## Addendum No.3

RFP Name: Culinary Art's Equipment

RFP# 2018-PUR-027

**Van Horn High School Addition and Remodel**  
1109 S. Arlington Avenue  
Independence, MO 64053

**FRONT ELEVATION**  
NOT TO SCALE

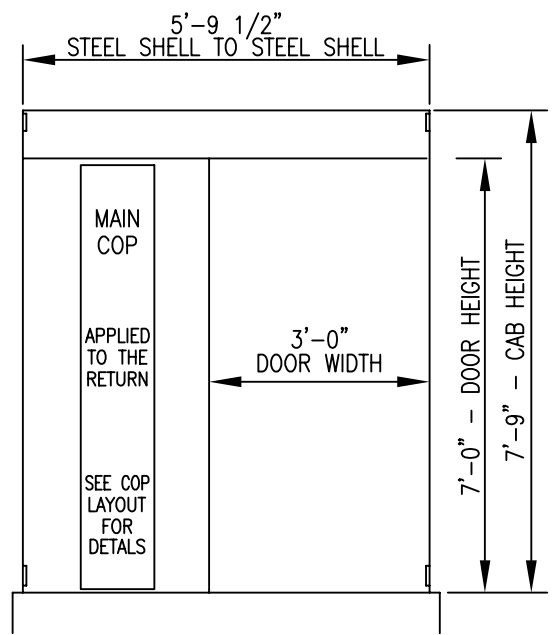
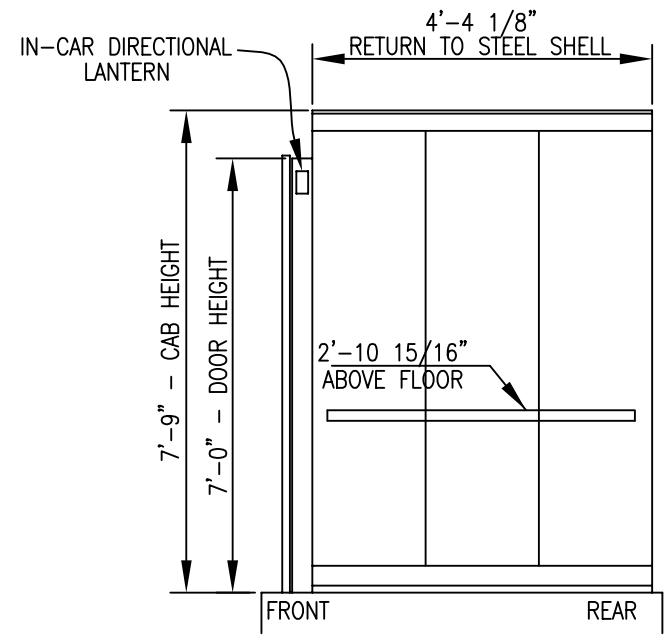
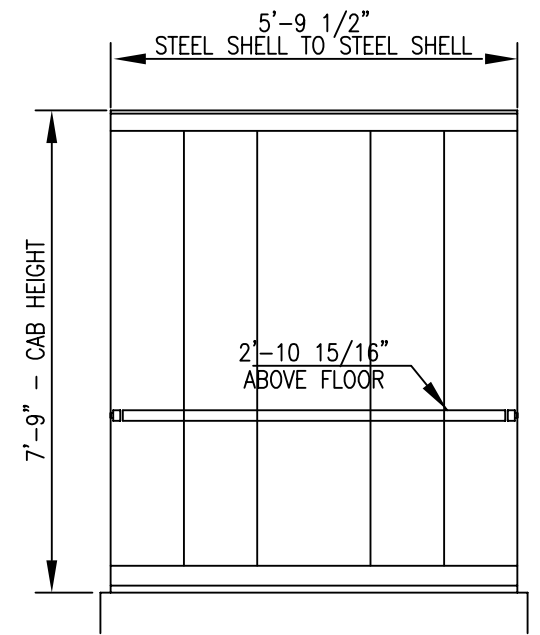
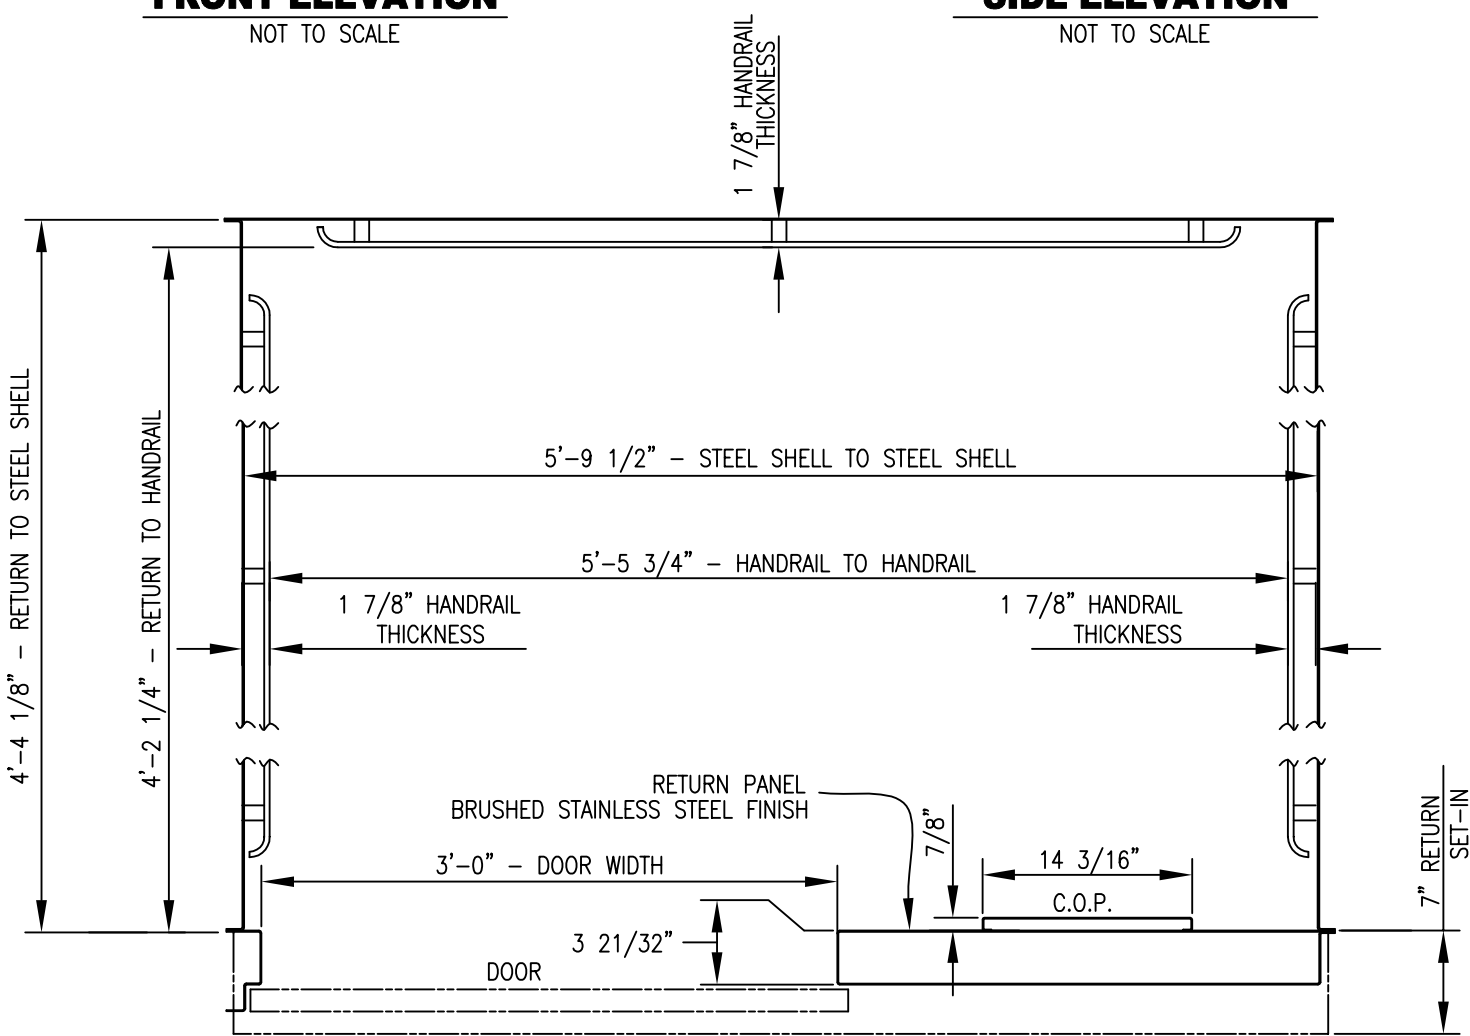
2. What are dimensions of elevator? We need to verify that walk in panels 4'xx4''x7'2.25'' and 3 hole sink will fit on elevators.

Elevator is 5'9.5"X4'4" wide and 7'9" tall. See below shop drawing from Elevator manufacturer. Expect the cab to be built very close to what they show in their drawings.
